**From:** [Niver, Robyn](#)  
**To:** [Lennon, Tiernan](#)  
**Subject:** Re: Indiana Bat Question  
**Date:** Thursday, April 20, 2017 12:03:05 PM  
**Attachments:** [image.png](#)

Hey Robyn - The excerpt below is from the BA we discussed yesterday (effects analysis for the Indiana bat):

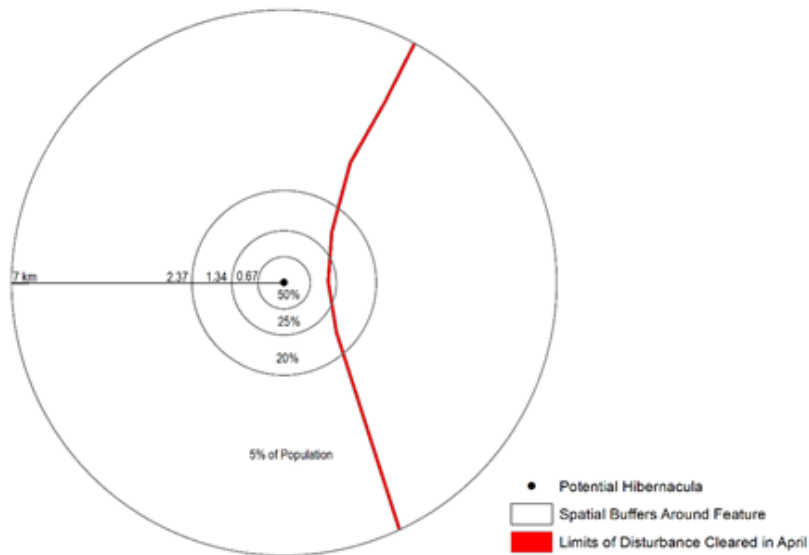
Everything in the first section is rationale. Lots of more recent information supporting various activity periods but this is fine.

This seems far too precise to support. Also, I reread that paper and don't understand how they used it to derive these zones. The paper discusses core activity areas (spring/summer/fall) within 4.75 km of hib. I could find nothing about 2.37, 1.24, 0.67 km.

They could just buffer potential hib by 4.75 km if they wanted to use this paper and suggest that areas outside of that distance may not have frequent spring or fall activity?
